Abbey Co-Op – Phase 2

| Delegated Report (Members Briefing) | | Analysis sheet | | Expiry Date: | | 09/09/2021 | |
| David Fowler | | | | 2021/2813/P | | | |
| Variation of condition 2 (Approved Plans) and condition 5 (Noise) granted under planning reference 2020/2486/P dated 27/11/20 for construction of a new health and community centre (Use Class D1), relocation of existing residential car park, along with landscaping, associated access, demolition of link bridge between Phases 2 and 3, and cycle parking. Alterations are namely providing more plant on the roof and one heat pump in the rear garden. | | | | | | | |

Figure 1 – Approved and proposed roof plan, showing pump in rear garden

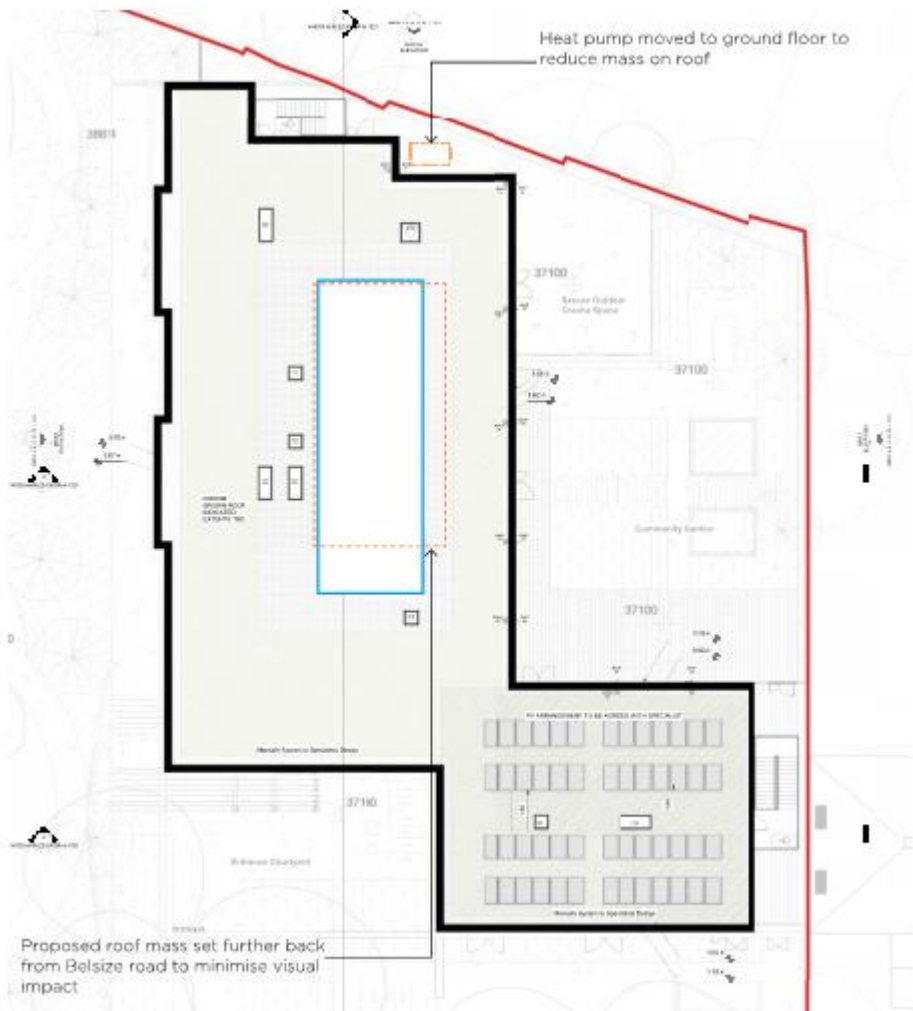
1.1 The current application seeks to make minor amendments to the application approved under permission reference 2020/2486/P dated 27 November 2020. The proposed changes are the reconfiguration of the approved roof plant, including moving one of the heat pumps from the roof to the rear at ground level. Larger fans are required due to technical issues (static pressure requirements).

- 1.3.2 No objections have been received on design grounds.
- 1.3.3 One of the heat pumps would be moved from the roof to ground level at the rear, where it would not be visible from public areas or surrounding properties.

- 1.3.4 The remainder of the proposed plant would remain in a central area of the roof to minimise visual impact. It would cover a wider area of the roof, but the plant would be set slightly lower. Given its location it would not be easily visible, as with the original application and is therefore considered acceptable in design terms. There would be no change to the materials proposed for the plant enclosure.

- 1.3.6 This alteration is not considered to harm the character and appearance of the host building, streetscene or wider South Hampstead Conservation Area in line with Policies D1 and D2.
